STAFF REPORT

Planning Commission

PC Date:	April 3, 2018	Case Planner:	Jenny Axmacher
CC Date:	N/A		
Location:	South East Corner of Buckley Road and East 88th Avenue (PIN 172300000106)		
Applicant:	Schuck Communities, Inc. 2 N. Cascade Ave. Suite 1280 Colorado Springs, CO 80903	Owner: Address:	Roarty Family LP 694 W. Majestic Ridge Place Oro Valley, AZ 85755

Case Summary	
Request:	Planning Commission review of a PUD Concept Schematic for an employment center that can accommodate a variety of airport related land uses including warehouses, flex space, light manufacturing, office, distribution and retail.
Project Description:	The applicant wishes to comprehensively develop an employment center directly to the north of the DIA Tech Center Development (Nexus at DIA).
Discussion Topics:	<ul style="list-style-type: none">• Allowed Land Uses/Comprehensive Plan Designation• Planning Areas• Proximity to Residential Development• Truck Traffic• Road connectivity
Key Approval Criteria:	A PUD Concept Schematic is neither approved nor denied. Therefore, no formal action is required from the Planning Commission.
Staff Recommendation:	N/A
Current Zone District:	A-3, Adams County Agricultural
Com

Figure 1.2

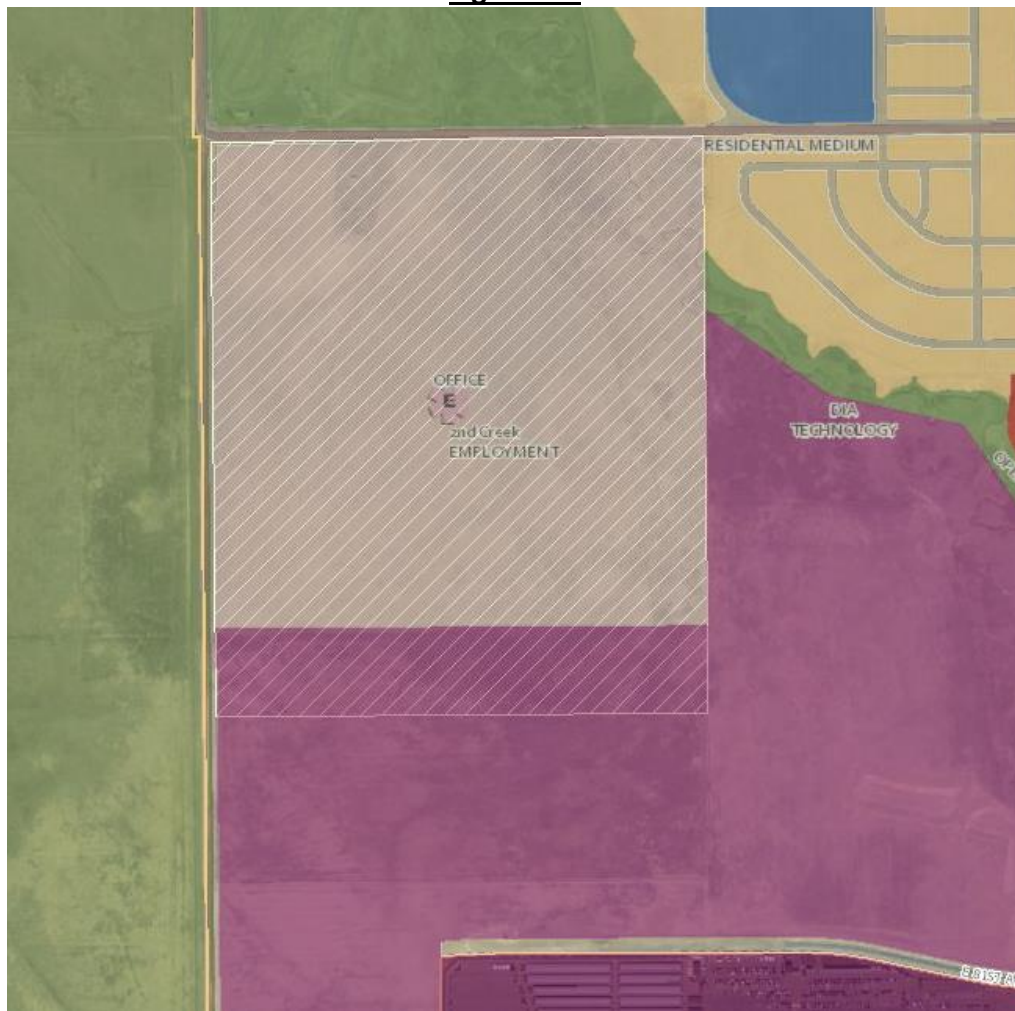
The request for I-2 type uses would be allowed by the Future Land Use Plan, however the DRT has concerns as to what the right balance of I-2 uses should be on the site and how much of the project should allow them. The Future Land Use Plan does not call out a large number of acres in the City for Office/Flex uses so staff want to make sure that the proper proportion of the project will be limited to these uses as they are vital to maintaining a balanced, economically healthy community.

The design criteria proposed for this development exemplifies the intent behind the Employment Center notation in the Future Land Use Plan and the DRT is supportive of the applicant's proposed standards.

Figure 1.3

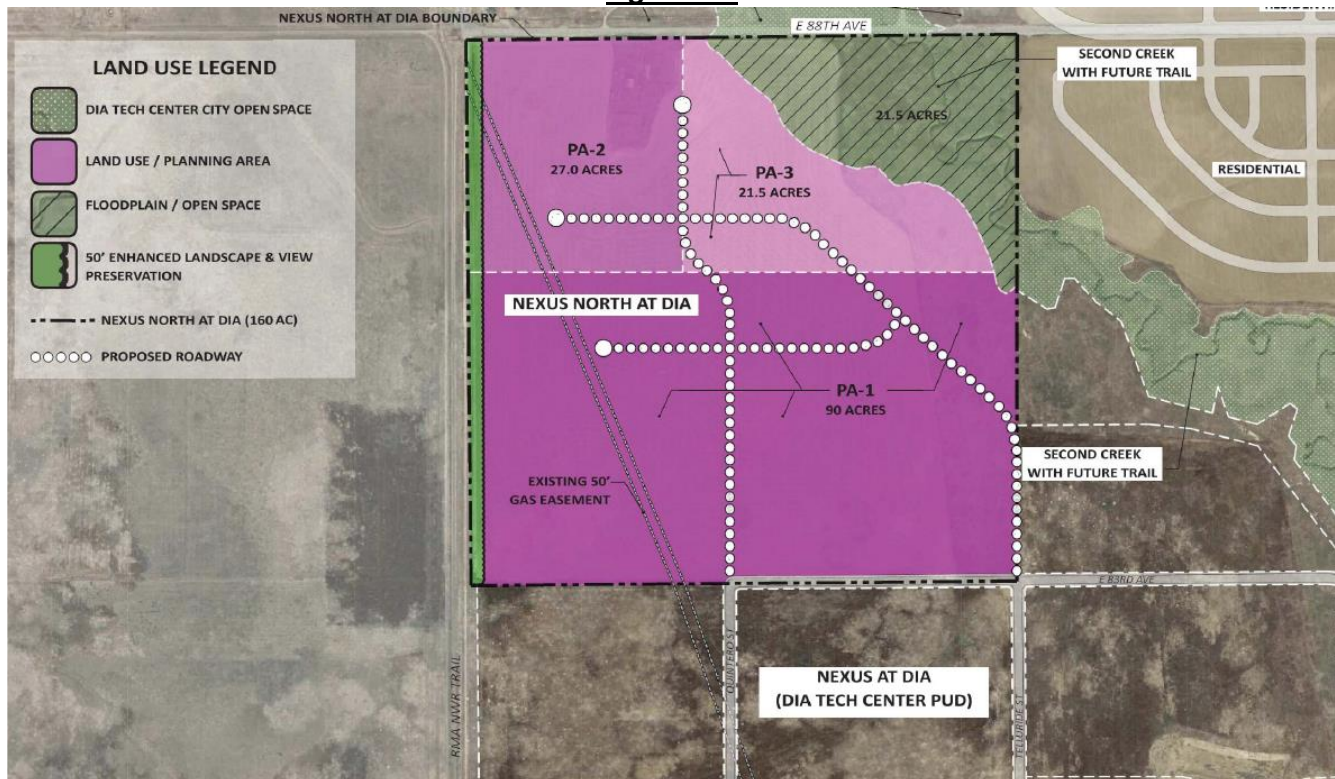
The applicant's proposed concept schematic consists of 3 proposed Planning Area, PA-1, PA-2, and PA-3, along with the area of Second Creek floodplain which is proposed to be open space. The schematic also shows a preliminary road network, a gas line easement and a buffer to the Rocky Mountain Arsenal National Wildlife Refuge. The differences between the three Planning Areas are the allowed uses. The Planning Area furthest south, PA-1 will allow the most intense industrial uses, similar to the DIA Tech Center project to the south. PA-2, to the north and west of PA-1 will allow less intense uses and PA-3, to the north and east of PA-1 will allow the least intense uses. This proposed transition takes into account the adjacent land uses with more industrial land uses to the south, open space to the west and residential to the north and east.
